80C196NU, 83C196NU SPECIFICATION UPDATE

Release Date: November, 1996

Order Number: 272864-002

The 80C196NU, 83C196NU may contain design defects or errors known as errata. Characterized errata that may cause the 80C196NU, 83C196NU's behavior to deviate from published specifications are documented in this specification update.

005. *RPD Signal*

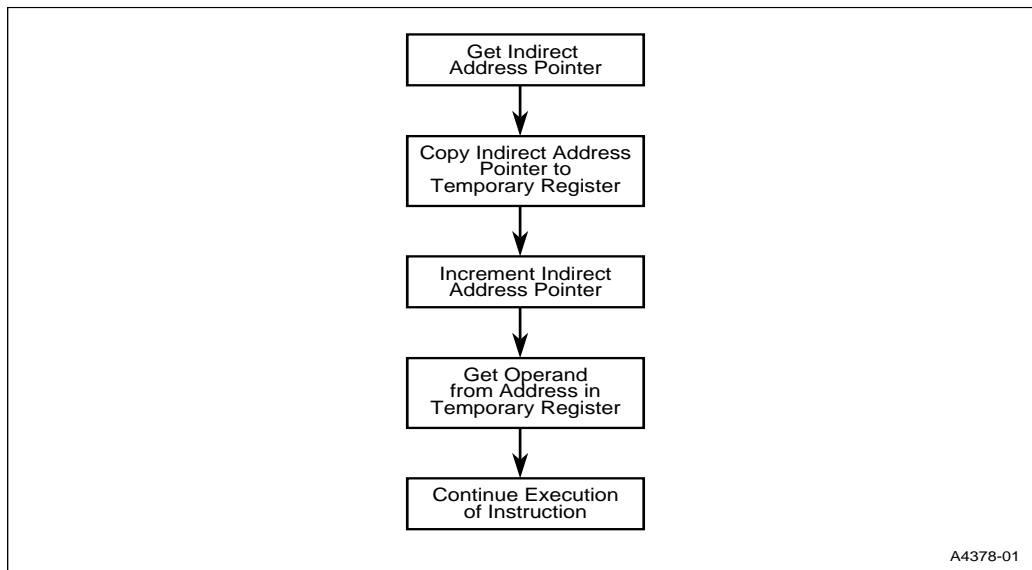
PROBLEM: If your application uses an external interrupt input to return to normal operation from powerdown mode, and the phase-locked loop (PLL) circuitry is enabled (see PLEN2:1 signal description), connect a capacitor between RPD and V_{SS}. The

capacitor is used to establish a delay of at least 2 ms to allow the PLL circuitry to stabilize before the internal CPU and peripheral clocks are enabled.

If your application uses powerdown mode, but the phase-locked loop (PLL) circuitry is disabled, the capacitor is not required.

If your application does not use the powerdown mode, leave the RPD pin unconnected.

023. *Recommendations for NC pins of QFP package.*

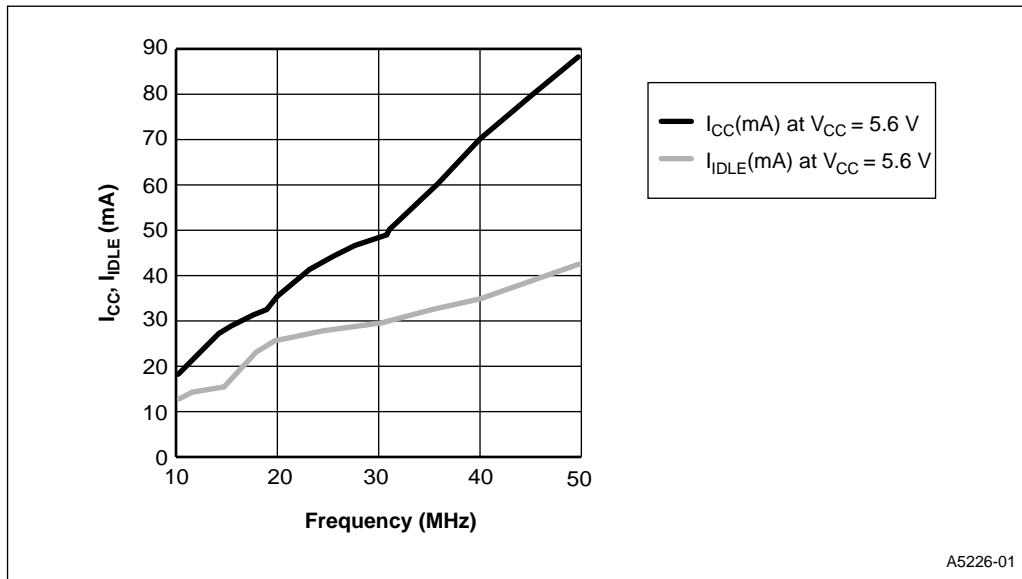
ITEM: Page 10, *8XC196NU Commercial CHMOS 16-bit Microcontroller* datasheet (272644-003)

The next revision of the datasheet will include the following recommendations for “no-connection” pins on the QFP package:

† To be compatible with future pin-compatible products, tie the NC (no connection) pins as follows.

80C196NU: pin 2 = Vss, pin 27 = NC, pin 5 = Vcc or Vss (for the 83C196NU and future pin-compatible devices with internal nonvolatile memory, pin 5 is EA#: Vcc = internal memory; Vss = external memory)

83C196NU: pin 2 = Vss, pin 27 = NC, pin 5 is EA# (Vcc = internal memory; Vss = external memory)

**80C196NU I_{CC} , I_{IDLE} versus Frequency**

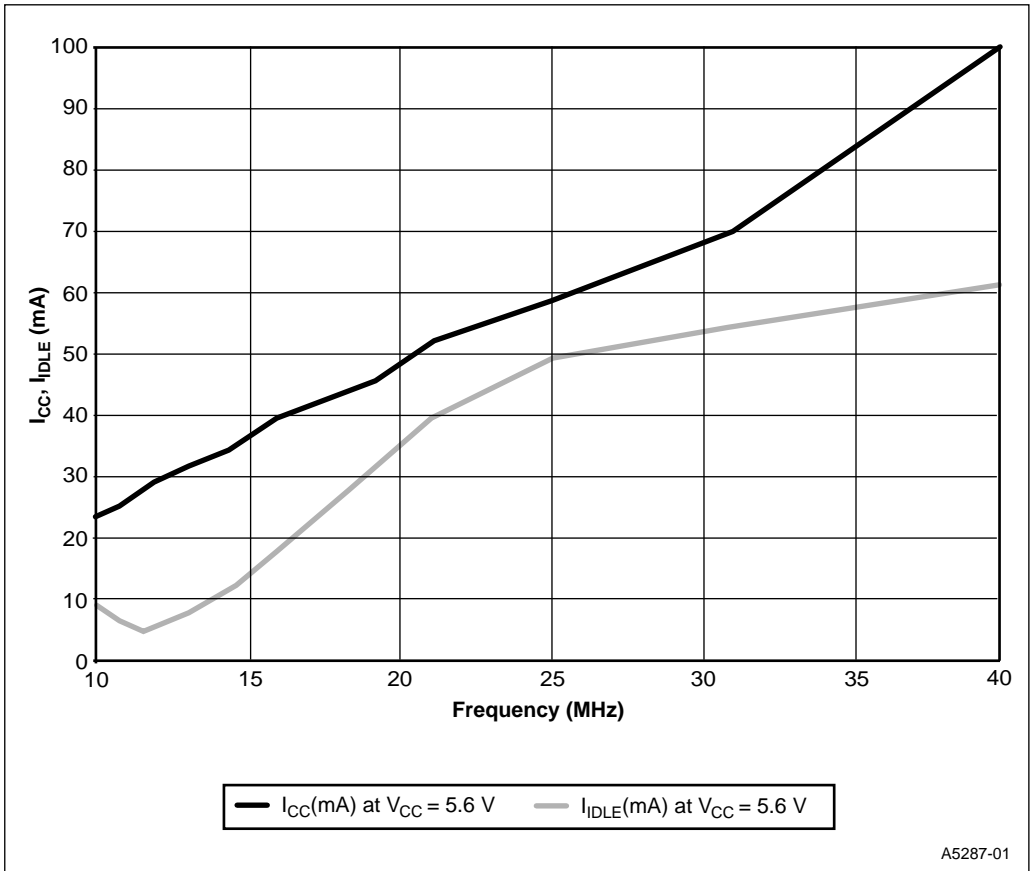
024. I_{CC} , I_{IDLE} versus Frequency**ITEM:** 8XC196NU Commercial CHMOS 16-bit Microcontroller datasheet (272644-003)

The following figures will be added to the next revision of the datasheet:
